1st June 2021

RE: Young Street Walking, Cycling and Streetscape Upgrades

Figure 3:
Examples of landscaping adjacent to existing Sutherland / Young St cycle path

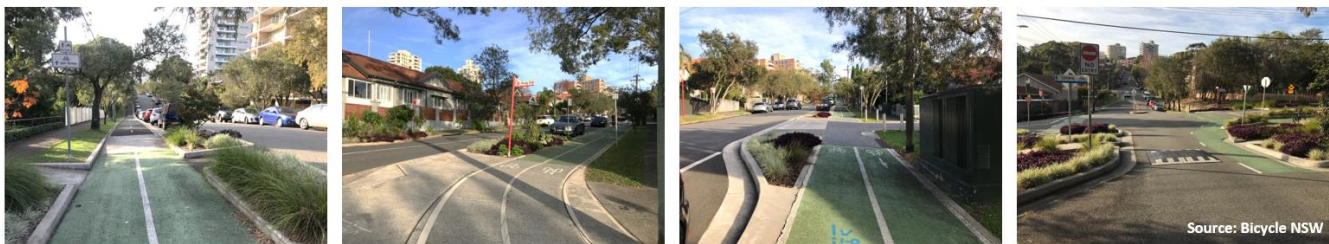
- The artist's impression does not indicate how the excellent landscaping installed adjacent to the existing section of the Sutherland Street / Young Street separated cycle path will be continued in the extended section. No landscaping or parking is shown alongside the cycle path. This may be the situation close to the junction with Belgrave St (where an extra peak hour turning lane is proposed) but presumably a buffer zone

of car parking and landscaped areas will protect the cycle path from the road along the rest of the Young Street Please submit more detailed landscape proposals as the project progresses.
